Our ref: P680020-FRA L05
 Your ref: 21/02286/F

Re: Construction of a coffee unit with drive-thru facility and indoor seating with associated access, car parking, landscaping and servicing parking. Land North West of Launton Road roundabout adjoining Skimmingdish Lane, Caversfield

Please find attached below the required information requested for the above application site. This letter has been produced to reflect the consultation responses from the Environment Agency (dated 9th January 2023, Environment Agency Ref: WA/2021/129266/05-L01) and the subsequent meeting held with the Environment Agency on the 30th January 2023.

FLOOD VOLUMES SECTION LAYOUT PLAN

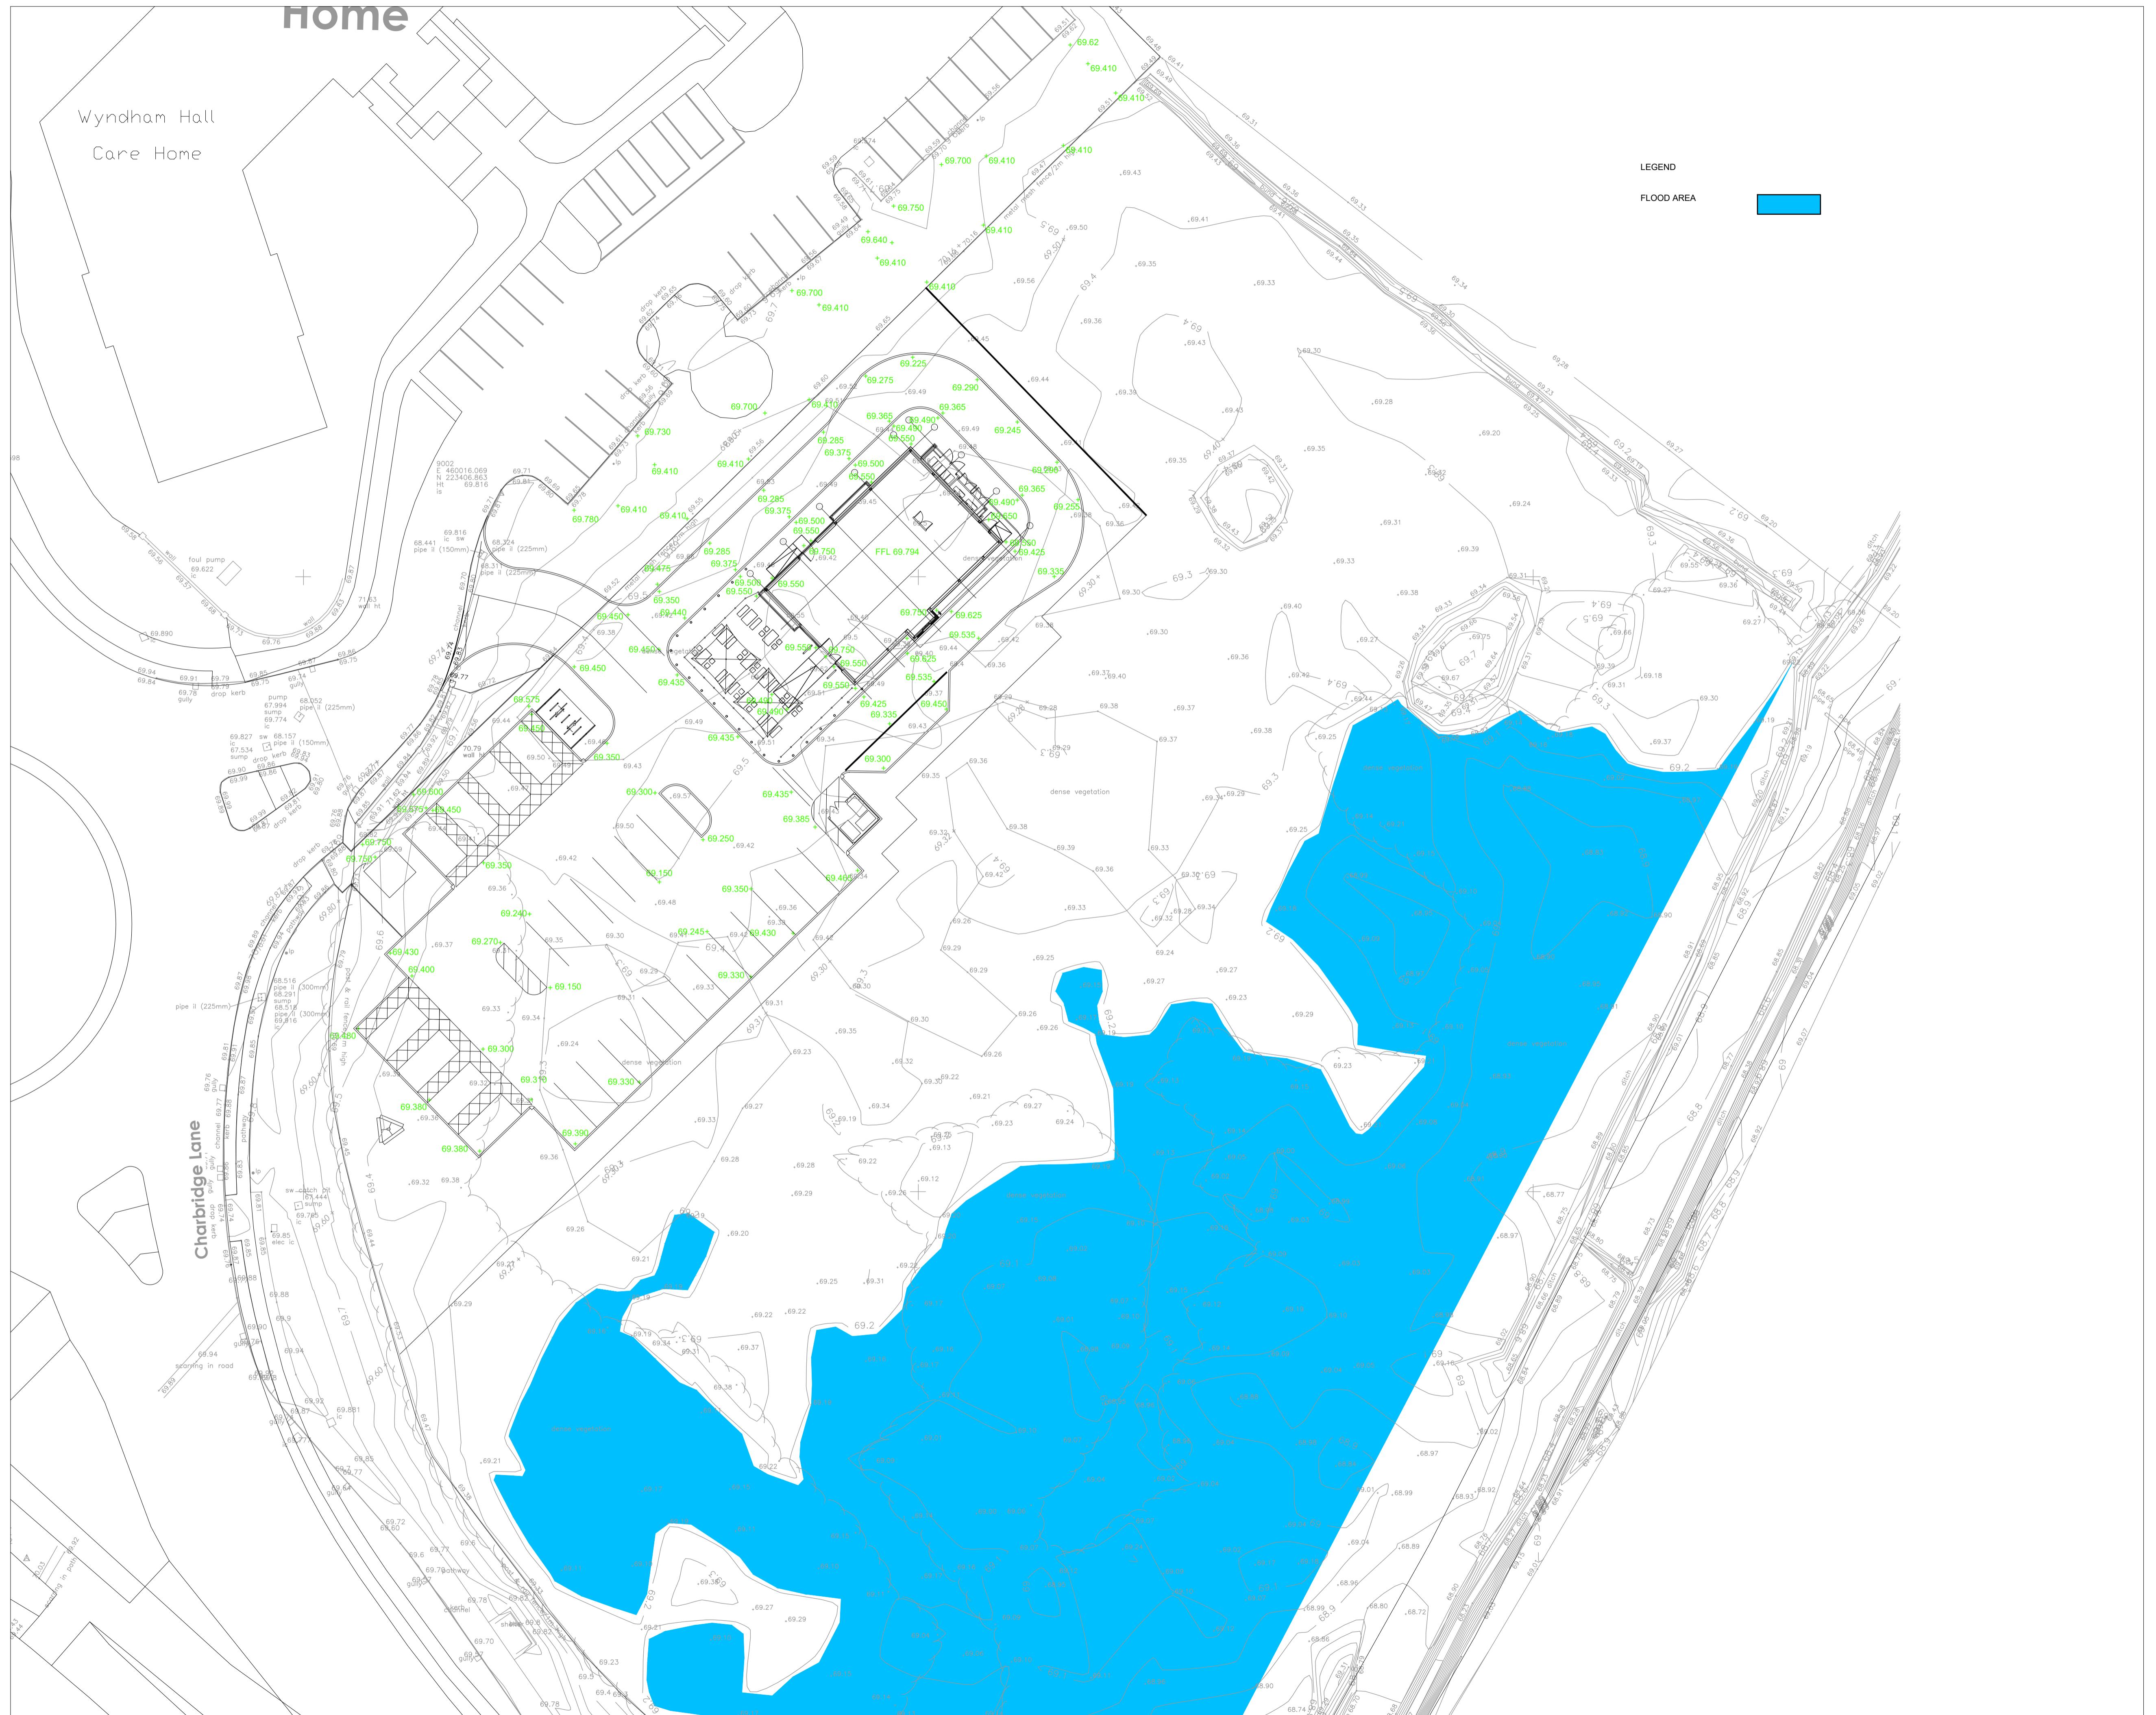
Environment Agency Comment	RSK Response
	<p>Drawing 220029/FV115_P2, FLOOD WATER MOVEMENT AT 69.794</p> <p>Drawing 220029_MX101_P1, SITE PLAN AND SECTION OF LANDSCAPE AREA</p>
<p>Further, the tank openings appear to be set at the wrong level for the flood band they are intended to be mitigating for. The applicant should explain why the tank openings are not provided at the bottom or middle of the relevant flood level band. These levels will also need to be revised in line with agreed flood levels for the site.</p>	<p>The inlets to the flood compensation tanks have been revised for the 2no flood level bands addressed by the tanks. The inlet levels are shown on drawing 220029/FV100_P9</p>

<p style="text-align: center;"><i>Positive figures indicate a reduction in flood volume</i></p> <p style="text-align: center;"><i>Negative figures indicate an increase in flood volume.</i></p> <p>* tank volume at 20m³ for this band</p> <p>** tank volume at 10m³ for this band</p> <p>Drawing 220029_FV100_P9 also provides the relevant attenuation across the calculated sections.</p> <p>The level for level compensation is being provided in the underground tanks with the inlets set at the required level (69.669mAOD and 69.769mAOD) to provide the level for level compensation and allows for hydraulic connectivity to the floodplain when the flood levels reach these inlets (see above extract). It can also be seen from the cross sections that the flood levels enter the car park, so whilst there is some displaced floodplain volume in some areas, there remains a hydraulic connectivity between all sections of the site and the flood zone, therefore the plans and associated calculations show a true representation of the situation.</p> <p>It can be seen from the tabulated outputs and the associated additional attention tanks that at all flood level increments, there is an increase in floodplain volume as a result of the development and therefore a reduction in flood risk on and off site.</p>	Total Volume Difference by level					Levels			Volume Difference (m ³) Excluding Tank	Volume Difference (m ³) Including Tank	Top (m)	Bottom (m)	Height (m)			69.794	69.69	0.104	19.06	-0.94 *	69.69	69.59	0.1	8.93	-1.08 **	69.59	69.49	0.1	-7.03	-7.03	69.49	69.39	0.1	-75.07	-75.07	69.39	69.29	0.1	-48.20	-48.20	69.29	69.19	0.1	-16.48	-16.48	69.19	69.09	0.1	-0.31	-0.31
Total Volume Difference by level																																																			
Levels			Volume Difference (m ³) Excluding Tank	Volume Difference (m ³) Including Tank																																															
Top (m)	Bottom (m)	Height (m)																																																	
69.794	69.69	0.104	19.06	-0.94 *																																															
69.69	69.59	0.1	8.93	-1.08 **																																															
69.59	69.49	0.1	-7.03	-7.03																																															
69.49	69.39	0.1	-75.07	-75.07																																															
69.39	69.29	0.1	-48.20	-48.20																																															
69.29	69.19	0.1	-16.48	-16.48																																															
69.19	69.09	0.1	-0.31	-0.31

Title
FLOOD WATER MOVEMENT AT 69.794

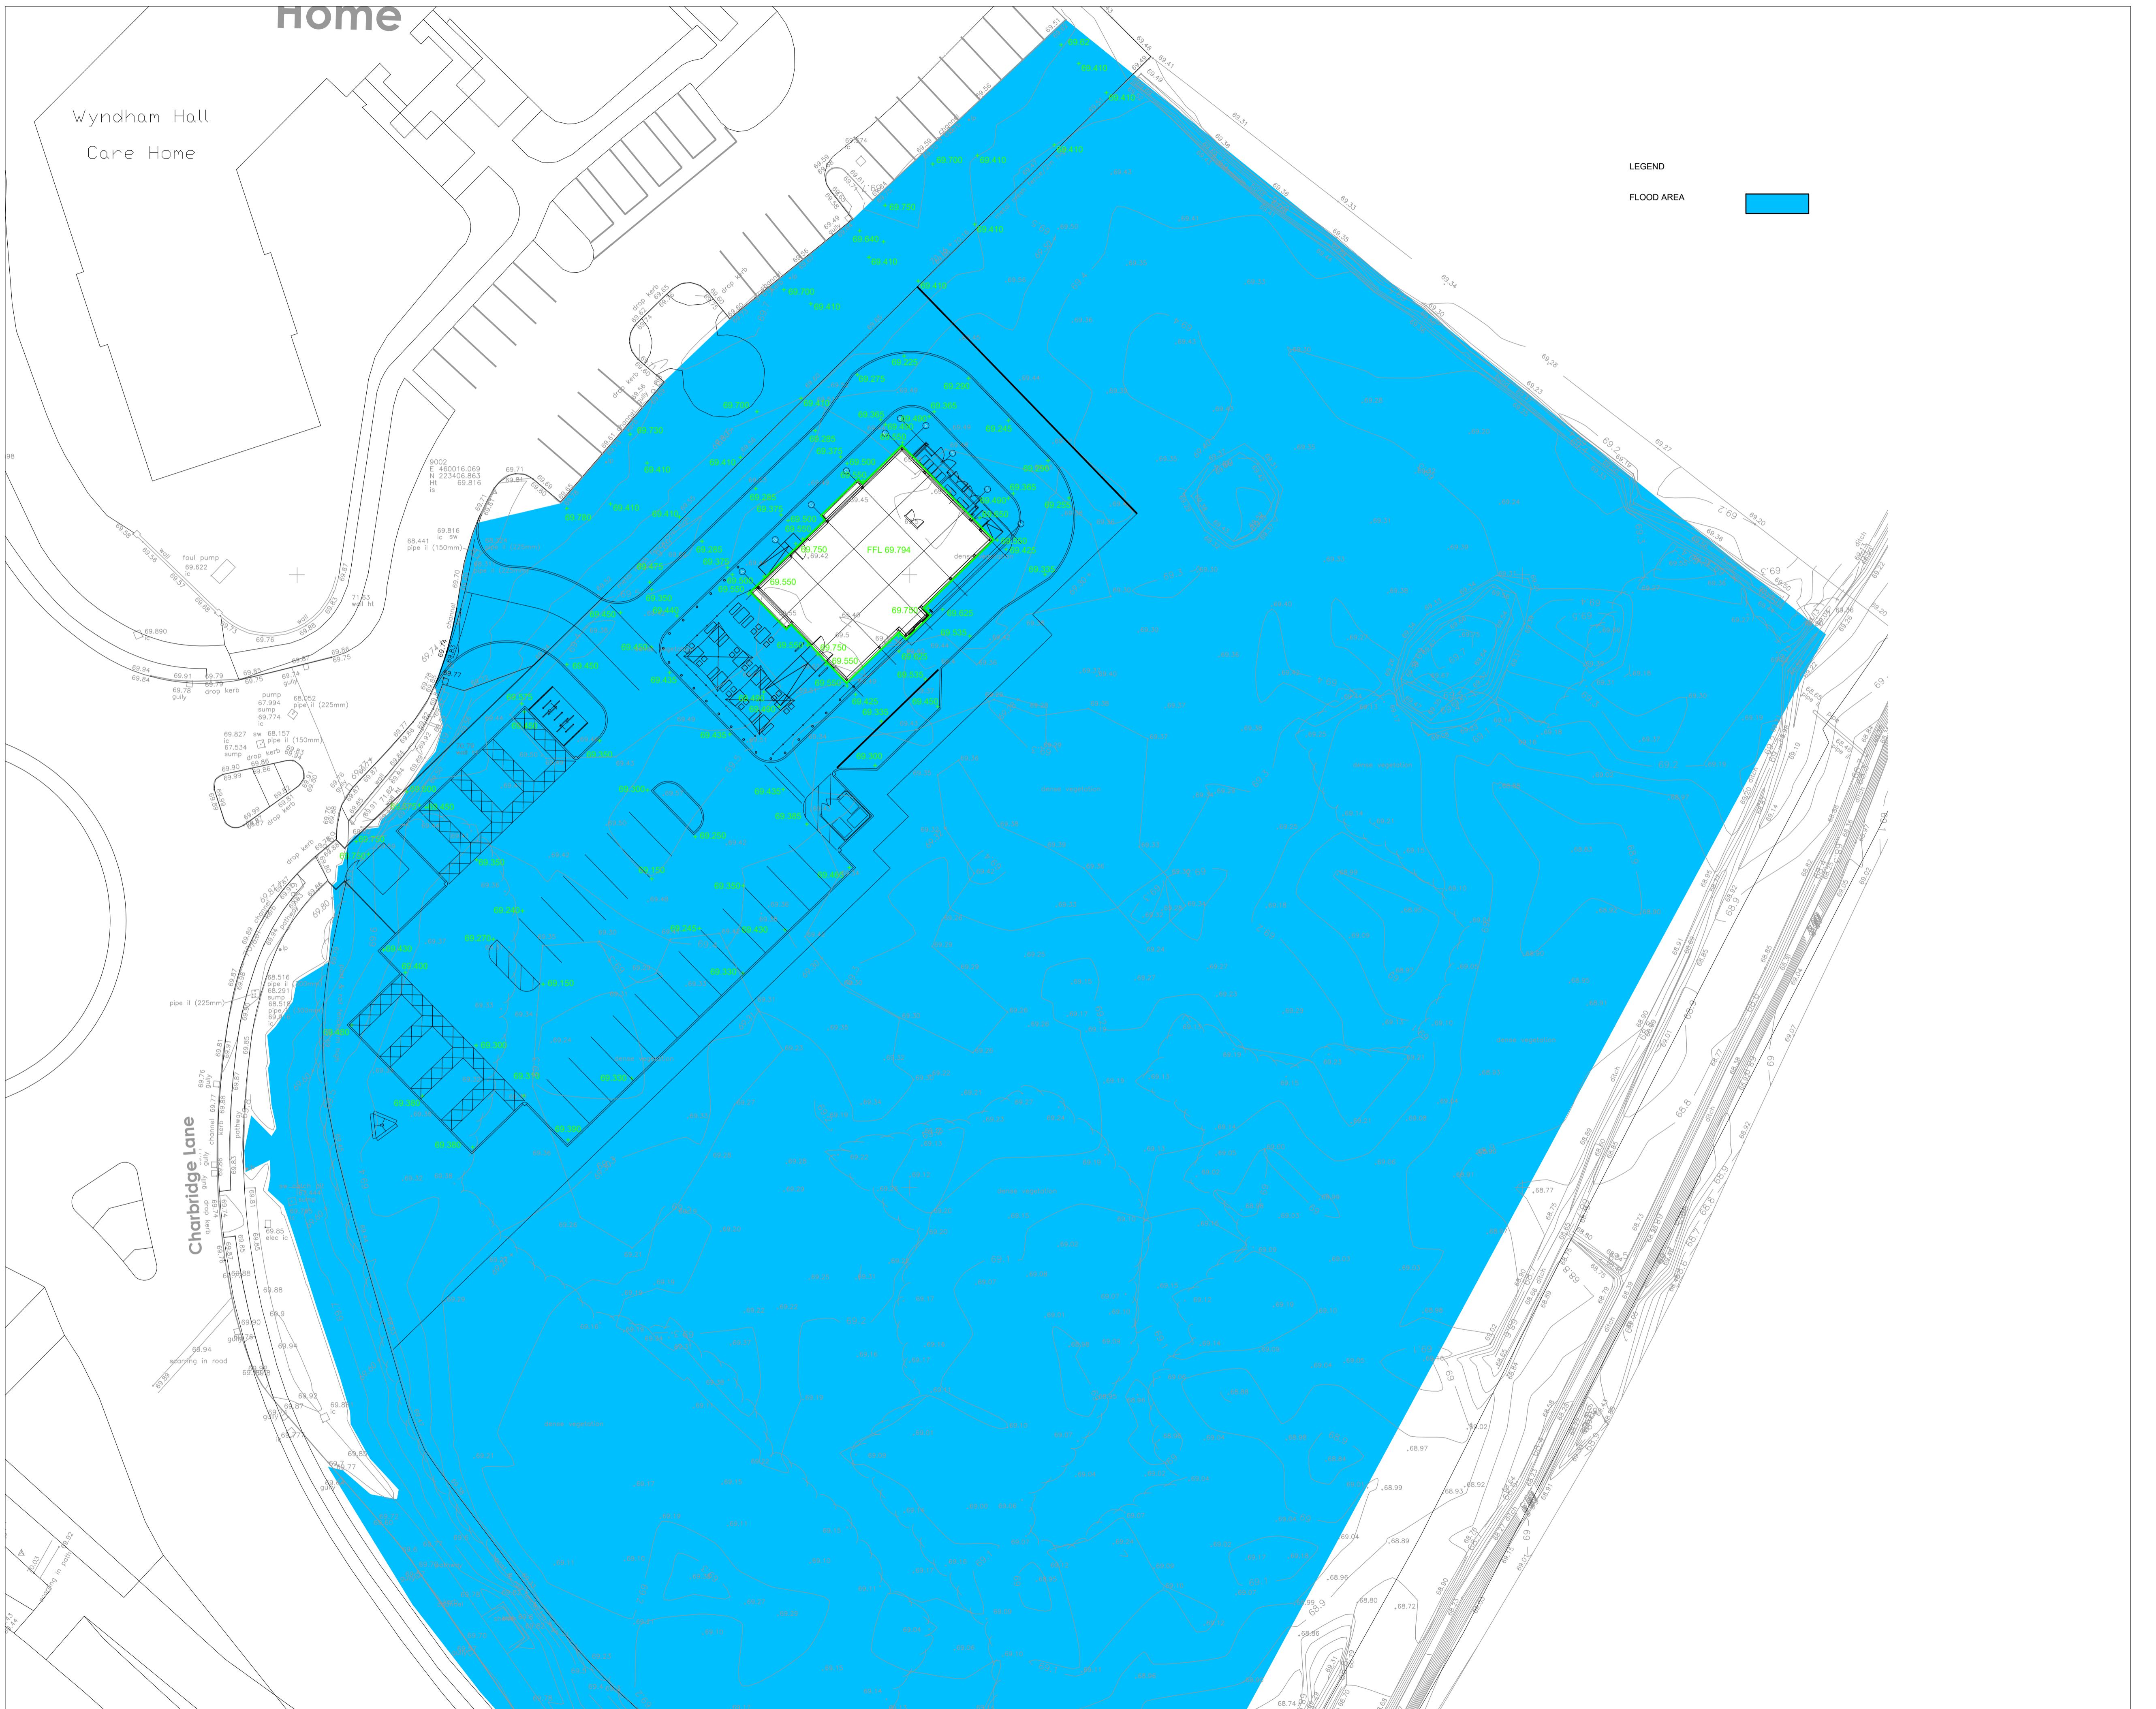
Environment Agency Comment	RSK Response
	<p>Further to this the control device and flood compensation tank are located within the flood plain at the agreed levels (69.669mAOD and 69.769mAOD) so as to ensure hydraulic connectivity is maintained.</p> <p>The individual plans outlined below contain the relevant cross sections throughout the development. The plans and the associated spreadsheet (below) clearly illustrate the impact of the scheme with respect to the flood compensation at the site.</p> <p>Slice by slice plan have been produced and included as drawings 220029_FV101_P11 to 220029_FV103_P11 and mapped extents per depth band included in 220029_FV109_P2 to 220029_FV115_P2</p> <p>The following plans have been provided to with respect to the revised compensation plans:</p> <p>Drawing 220029/FV100_P9 FLOOD VOLUMES SECTION LAYOUT PLAN.</p> <p>Drawing 220029/FV101_P11 FLOOD VOLUMES SECTIONS</p> <p>Drawing 220029/FV102_P11 FLOOD VOLUMES SECTIONS.</p> <p>Drawing 220029/FV103_P11 FLOOD VOLUMES SECTIONS.</p> <p>Drawing 220029/FV109_P2, FLOOD WATER MOVEMENT AT 69.190</p> <p>Drawing 220029/FV110_P2, FLOOD WATER MOVEMENT AT 69.290</p> <p>Drawing 220029/FV111_P2, FLOOD WATER MOVEMENT AT 69.390</p> <p>Drawing 220029/FV112_P2, FLOOD WATER MOVEMENT AT 69.490</p> <p>Drawing 220029/FV113_P2, FLOOD WATER MOVEMENT AT 69.590</p> <p>Drawing 220029/FV114_P2, FLOOD WATER MOVEMENT AT 69.690</p>

SITE PLAN AND SECTION OF LANDSCAPE AREA

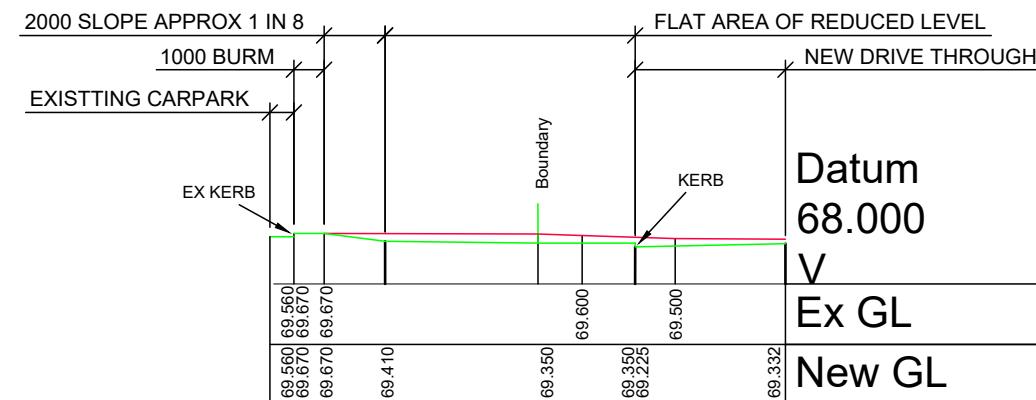
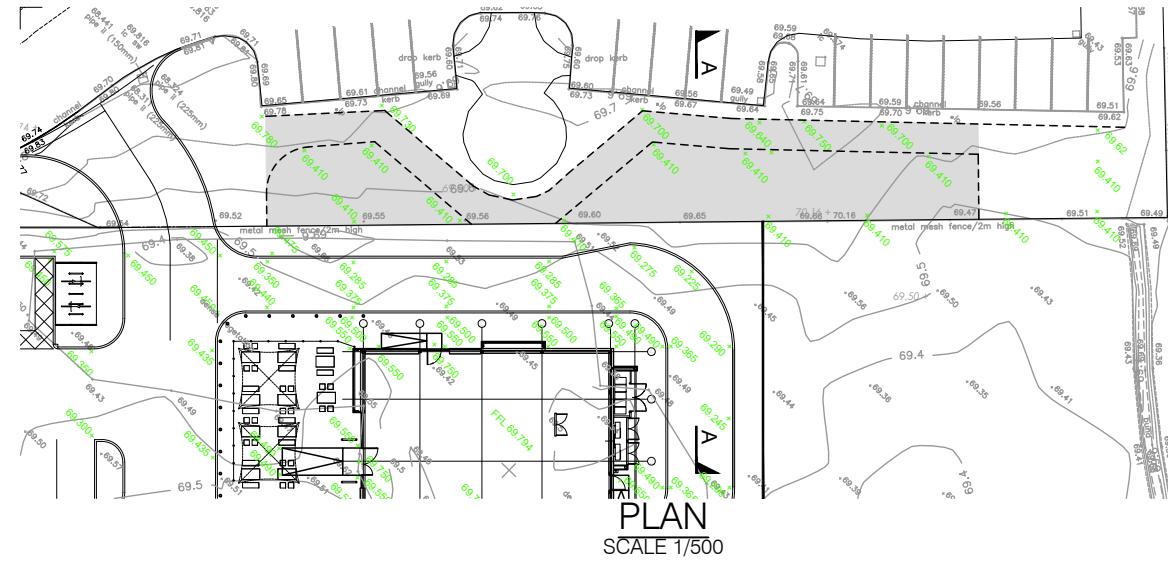
Environment Agency Comment	RSK Response
<p>certainly be below the 6% climate change flood level which is yet to be determined. This means the development would be at risk of flooding internally</p>	
<p>In addition, the applicant's flood mitigation scheme, which is a combination of level for level flood compensation and storage tanks, must be revised to account for the higher climate change flood level in order to ensure the proposal can replace lost flood storage on a level for level basis and that the storage tanks will operate in the correct way to reduce the flood risk impact. Also, the applicant has still not demonstrated that the level for level compensation scheme will be hydraulically connected. We previously requested a plan/s which clearly mark the extents of each compensation slice so we can visually see how they would be hydraulically connected. This has not been provided. The submitted supporting letter (reference P680020-FRA L04, dated 11 October 2022, prepared by RSK LDE) states: 'we have assessed the situation and removed the kerb from the development proposals (highlighted location in the above extract) to aid in the hydraulic connectivity between the site and the flood plain'. However, from the plans submitted it can still not be seen if each slice of the level for level compensation scheme is hydraulically connected. This is required to ensure the compensation scheme can function over a range of flood events up to and including the relevant climate change event.</p>	<p>Following discussions with the EA, revisions have been made to the compensation scheme to ensure that the flood compensation volume required within the tanks remains below the 30m³ as previously agreed as suitable for the scheme.</p> <p>A revised suite of drawings has been produced to reference the provided EA flood levels and revisions to the scheme.</p> <p>Drawing reference 220029_FV100_P9 supersedes the former P7 version shows the site and the wider area floodplain offset and gain.</p>  <p>The blue areas show where additional floodplain volume is created and the red where levels have been raised and volume is offset (note flood volume beyond the hatched limits has not been taken into account). The P8 version includes additional areas of land secured as part of the revised levels proposals.</p> <p>Drawings 220029_FV109_P2 to 220029_FV115_P2 represent the flood water movement at 100mm increments in a visual format, with drawings 220029_FV101_P11 to 220029_FV103_P11 providing the cross section drawings.</p> <p>The additional drawings have been produced and show additional levelling works on site (north east of</p>

Environment Agency Comment	RSK Response																																													
	<p>proposed building) and offsite (area to the north / north west of the site) which aid in securing the flood compensation level for level strategy.</p> <p>Drawing 220029_MX101_P1 provided highlights the additional area of ground lowering to the north of the site.</p>  <table border="1" data-bbox="857 920 1302 1100"> <tr> <td>69.09</td> <td>69.10</td> <td>69.11</td> <td>69.12</td> <td>69.13</td> <td>69.14</td> <td>69.15</td> <td>69.16</td> <td>69.17</td> <td>69.18</td> <td>69.19</td> <td>69.20</td> <td>69.21</td> <td>69.22</td> <td>69.23</td> <td>69.24</td> <td>69.25</td> <td>69.26</td> <td>69.27</td> <td>69.28</td> <td>69.29</td> <td>69.30</td> <td>69.31</td> </tr> <tr> <td>69.09</td> </tr> </table> <p>Agreement has been made with the land owner to the north to secure the right to regrade and lower this section of land (grey hatched area).</p> <p>It can be seen from the tabulated outputs contained in the drawing notes on drawing 220029_FV100_P9 that for each 100mm increment between 69.09m AOD and 69.59m AOD there is additional floodplain storage totalling up to 147.03m³.</p> <p>Once the flood level reaches 69.59m AOD, there is a displacement of floodplain for this 100mm increment and the 104mm increment to the top water level of 69.794m AOD by the order of 27.988m³, hence the requirement for additional attenuation at this level as previously agreed with the EA in the amount of 30m³ providing in excess of 2m³ surplus capacity.</p>	69.09	69.10	69.11	69.12	69.13	69.14	69.15	69.16	69.17	69.18	69.19	69.20	69.21	69.22	69.23	69.24	69.25	69.26	69.27	69.28	69.29	69.30	69.31	69.09	69.09	69.09	69.09	69.09	69.09	69.09	69.09	69.09	69.09	69.09	69.09	69.09	69.09	69.09	69.09	69.09	69.09	69.09	69.09	69.09	69.09
69.09	69.10	69.11	69.12	69.13	69.14	69.15	69.16	69.17	69.18	69.19	69.20	69.21	69.22	69.23	69.24	69.25	69.26	69.27	69.28	69.29	69.30	69.31																								
69.09	69.09	69.09	69.09	69.09	69.09	69.09	69.09	69.09	69.09	69.09	69.09	69.09	69.09	69.09	69.09	69.09	69.09	69.09	69.09	69.09	69.09
